STAFF RECOMMENDATION

**814 Boscobel Street
February 19, 2014**

Application: Alterations-windows and materials; New construction-addition

Description of Project: The applicant proposes to replace windows and siding on the existing house, and to build a one and one-half story rear addition.

814 Boscobel Street, left. Note the non-original window and siding at the rear of the gabled projection.

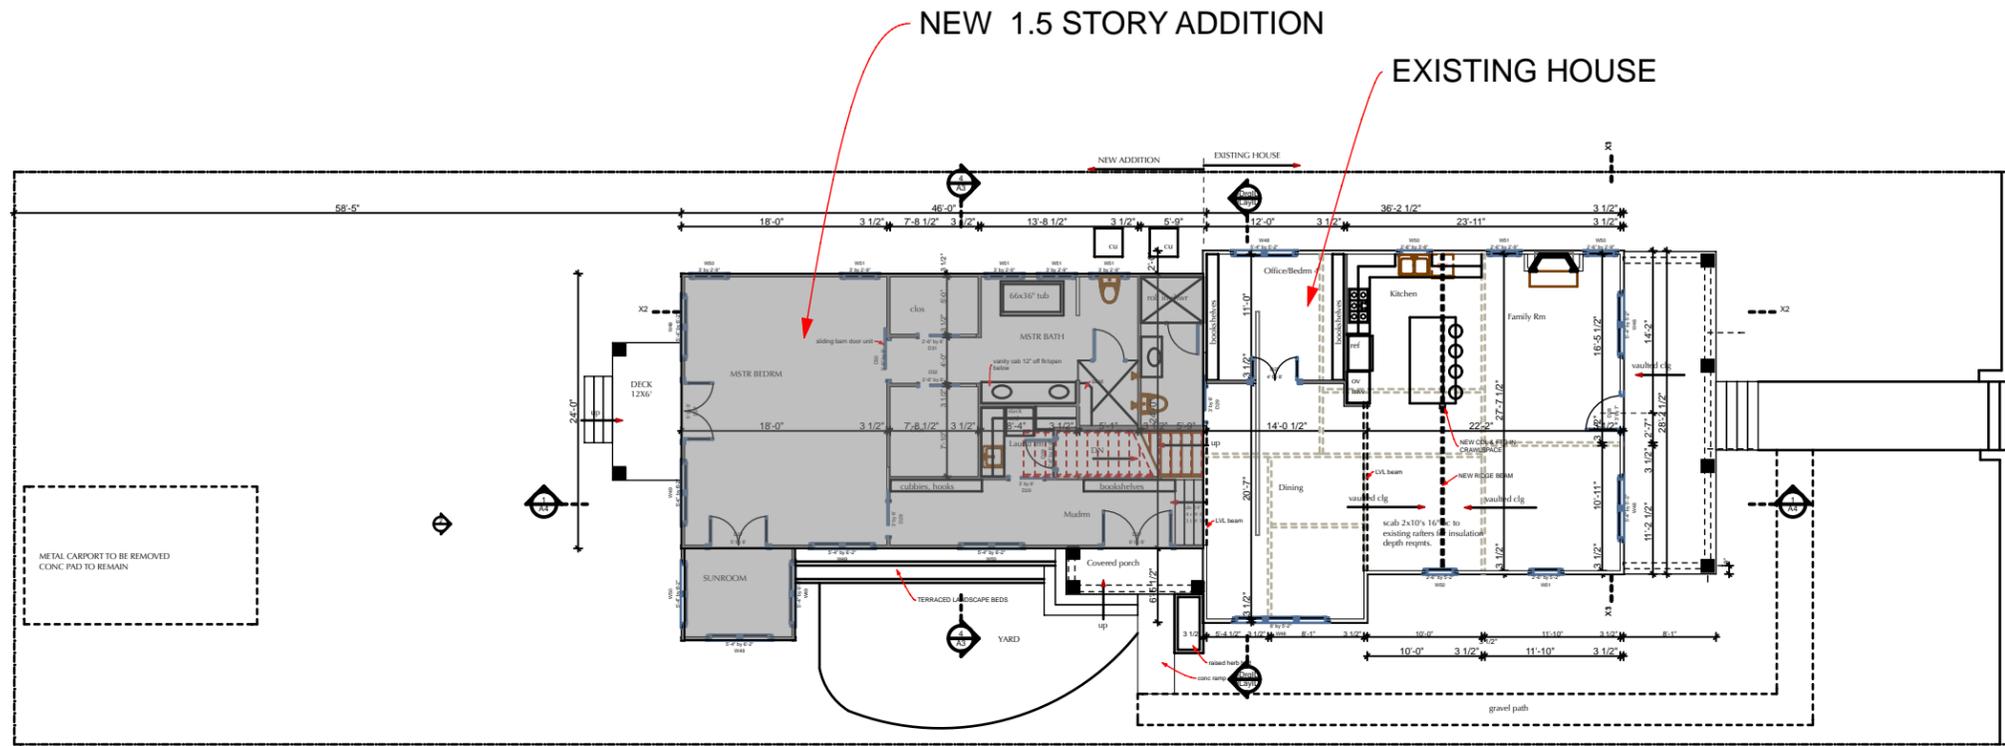
The plans also indicate that the siding on the existing left-side projection will be replaced. The rear portion of this projection was originally an open porch that has been enclosed. Because this portion of the house has been altered, replacing the non-historic materials would be appropriate but there should be a cornerboard or other visual distinction between the old and the new materials. Replacing the original materials on the rest of the projection, however, would not meet guideline II.B.5.a

SITE PLAN

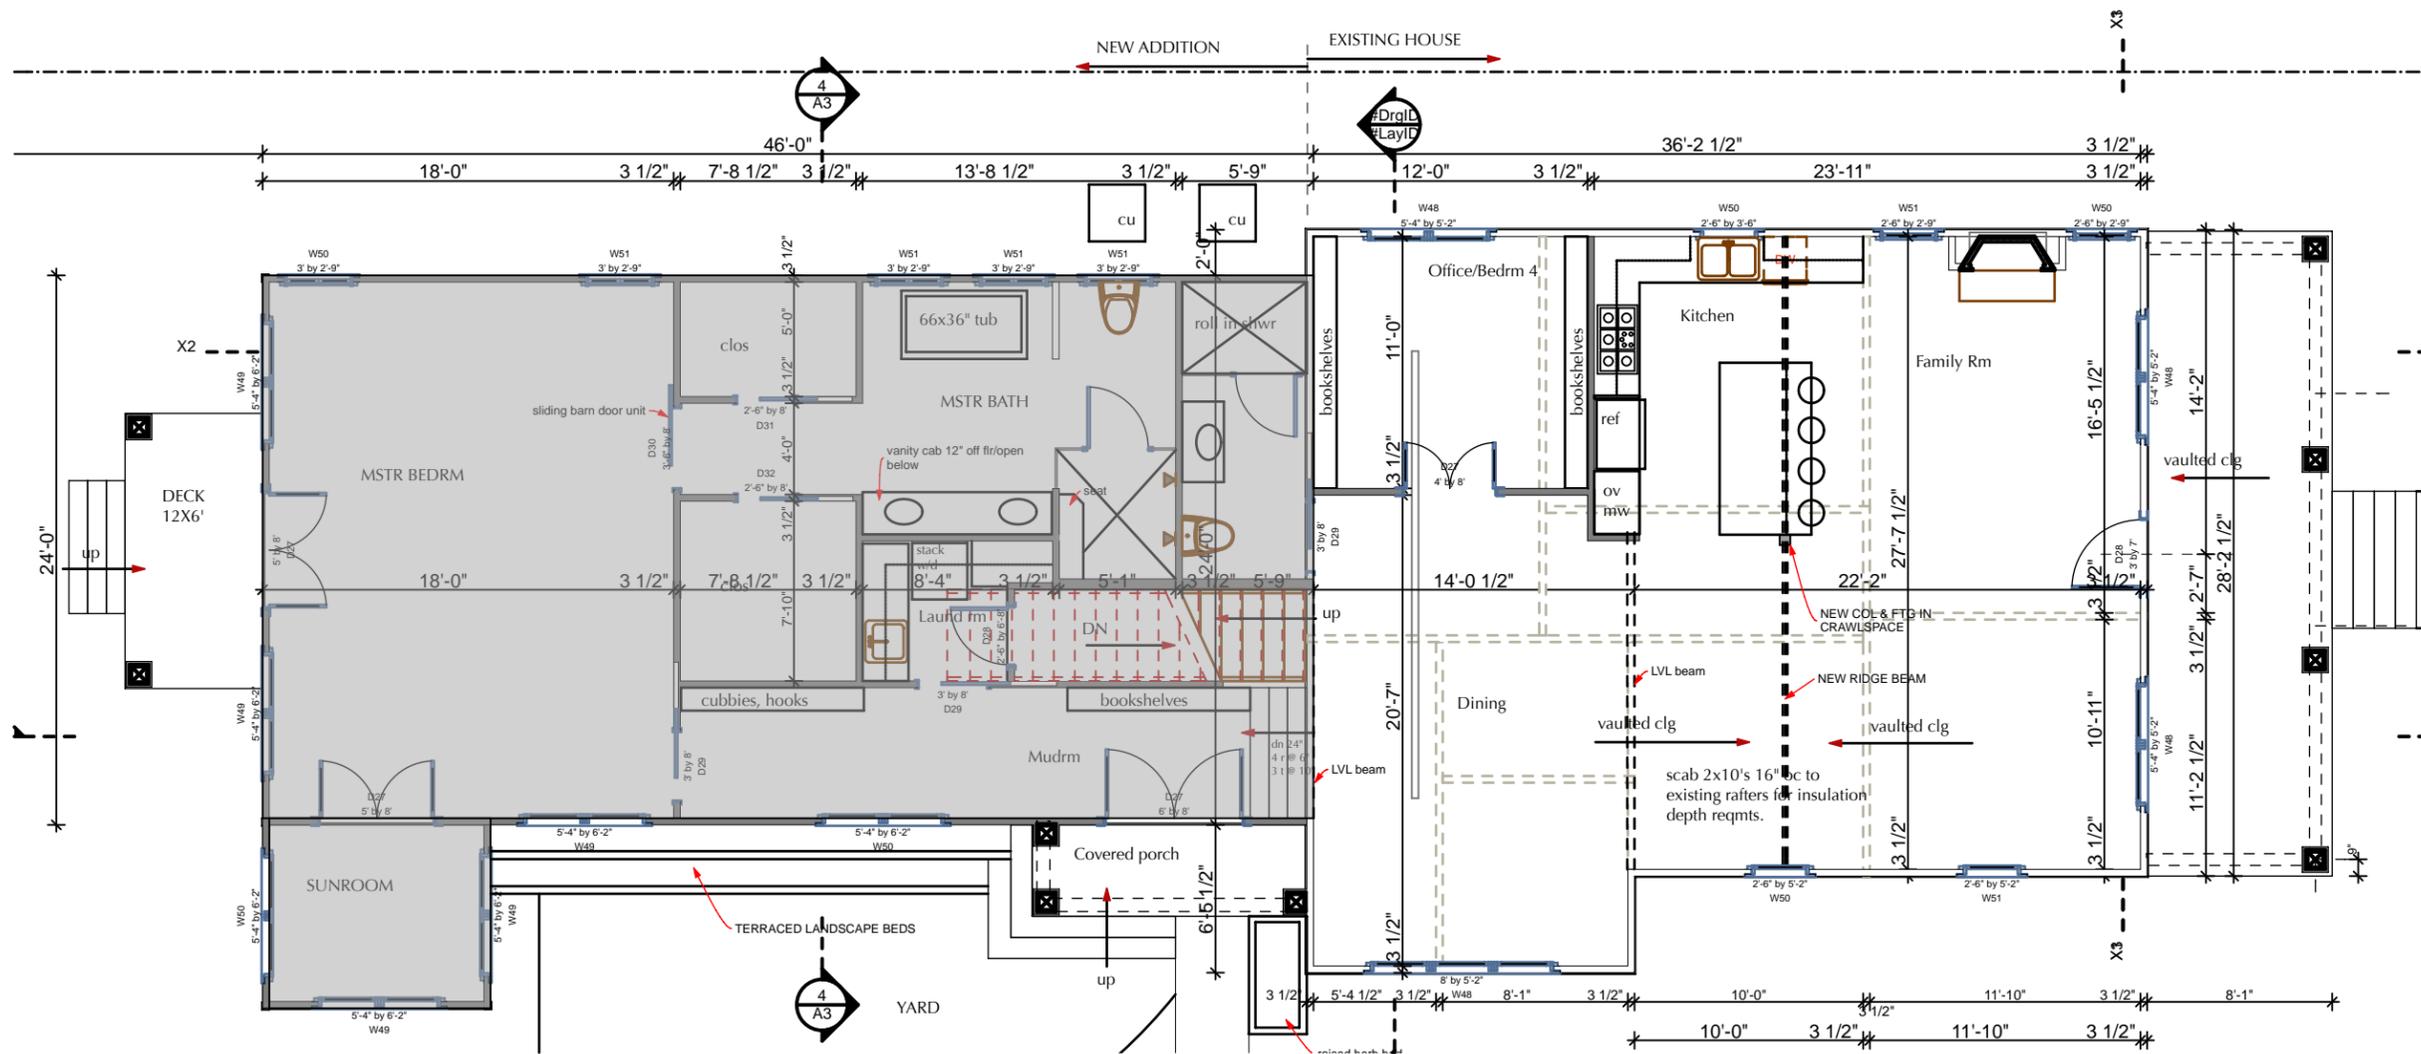
The site plan indicates that the HVAC will be relocated from the left side of the house to the right, at a point beyond the midpoint of the house. This is an appropriate location.

ROOF PLAN

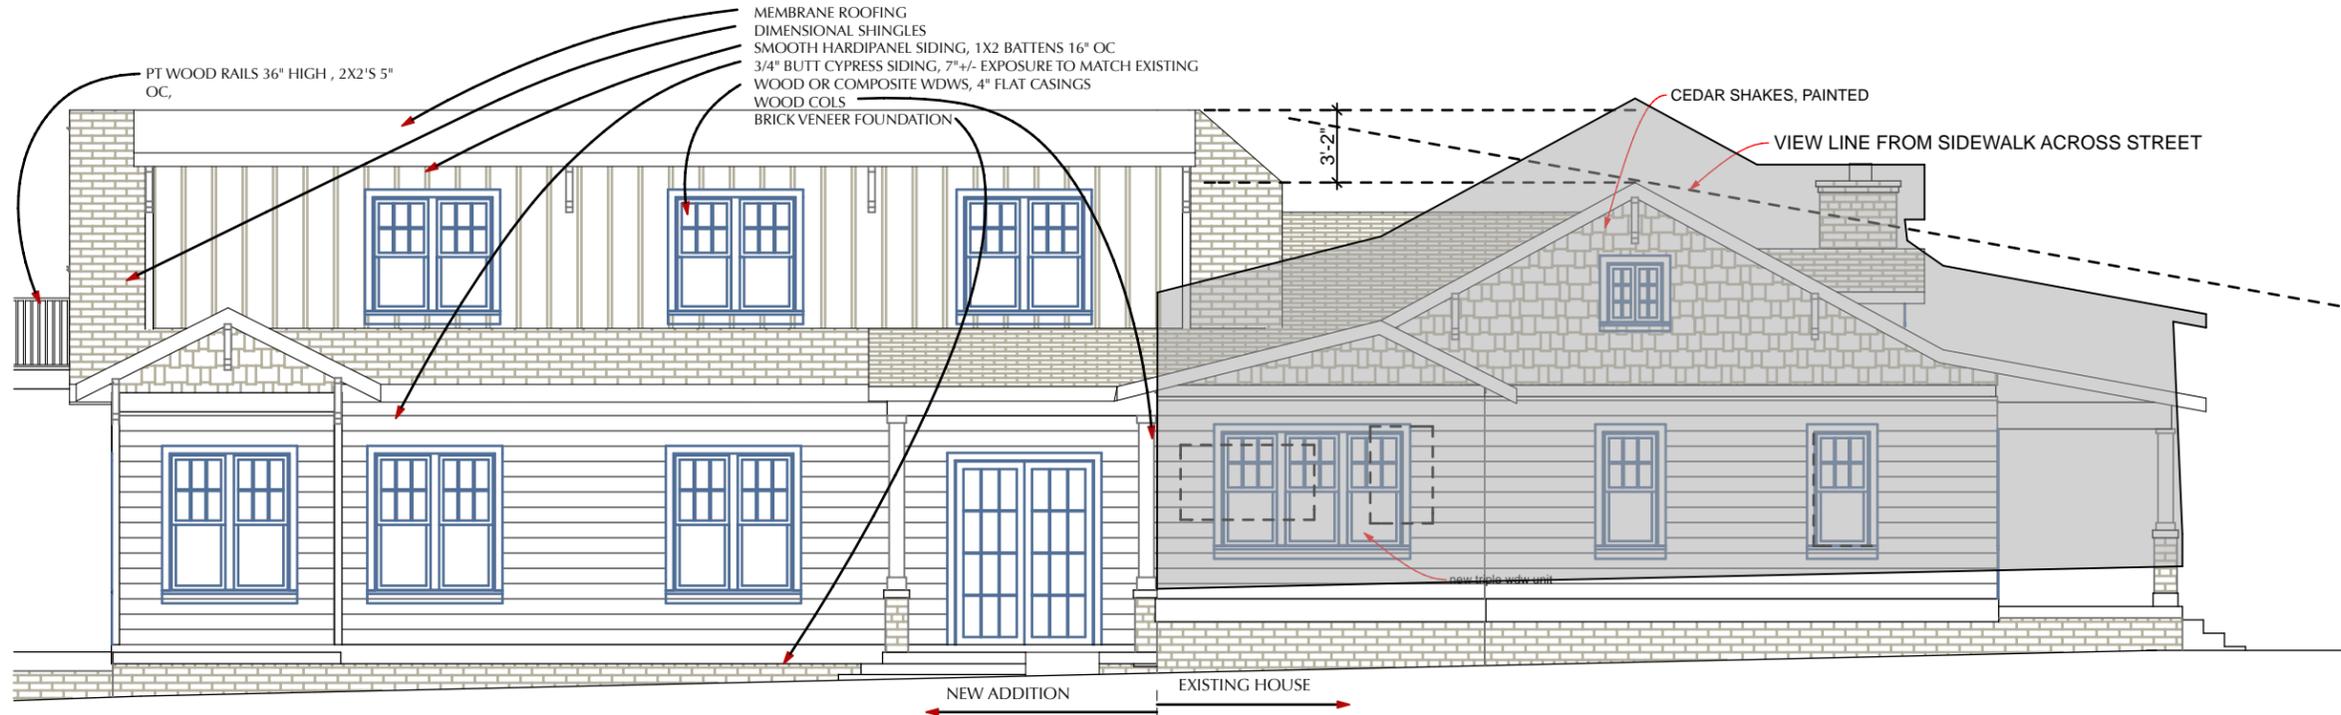
The roof of the addition will be a 10:12 pitched gable, with 2:12 pitched shed-roofed dormers on each side. Staff finds that the dormer eaves will be visible in a manner contrasting greatly with the historic house, which does not meet guidelines III.B.1.c and III.B.1.d. Staff recommends as a condition of approval that the dormer roof pitches should be lowered so that the eaves are not higher than the ridge of the historic house.

ELEVATIONS - SIDES

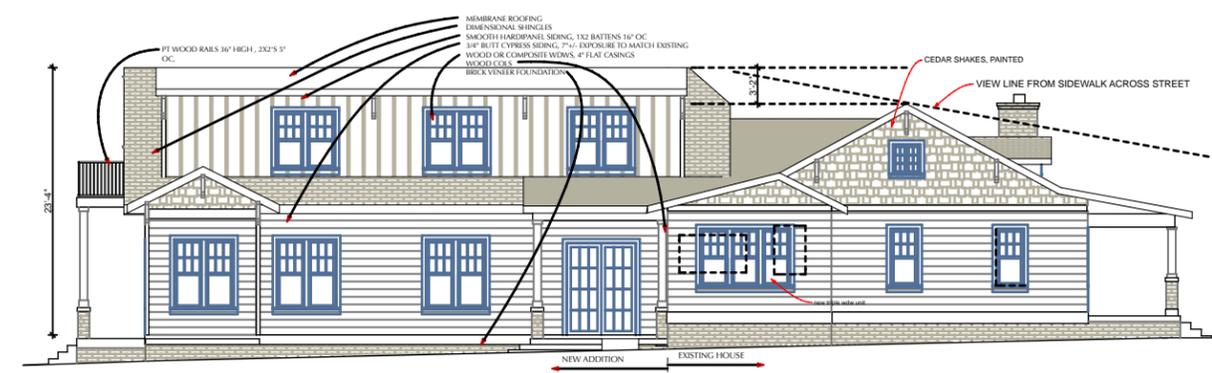
The foundation will step down two feet (2') lower than the height of the existing foundation, which helps to allow the addition to have more of an upperstory and minimize the overall height. Although the primary eave of the addition will align with the eaves of the historic house, the eaves of the upperstory dormers will be one foot (1') higher than the ridge of the historic house. Staff finds that these eaves will be visible in a manner contrasting greatly with the historic house, which does not meet guideline III.B.1.c and III.B.1.d. Staff recommends as a condition of approval that the dormer roofs should be lowered so that the eaves are not higher than the ridge of the historic house.

The plans indicate that some of the original windows on the left and right sides of the house will be removed and replaced with new ones with different sizes. This does not meet guideline II.B.3.a, which says that “original details, size, shape, number and arrangement of panes, and all other visual characteristics [of windows] should be retained.” It also would not meet guideline II.B.5.a, which says “original building materials should be retained.” The window furthest to the rear on the existing projection, however, is not original and therefore its replacement would be appropriate.

- The eaves of the dormers are lowered to the height of the ridge of the roof or lower;
- The original windows on the historic house are retained;
- The original wood siding on the historic house is retained, and that new siding is distinguished from the historic materials;
- The asphalt-shingle siding on the historic house is replaced in-kind;
- Staff approves the doors, windows, brick, roof color, paving, walls and fences, and any other exterior materials prior to selection.
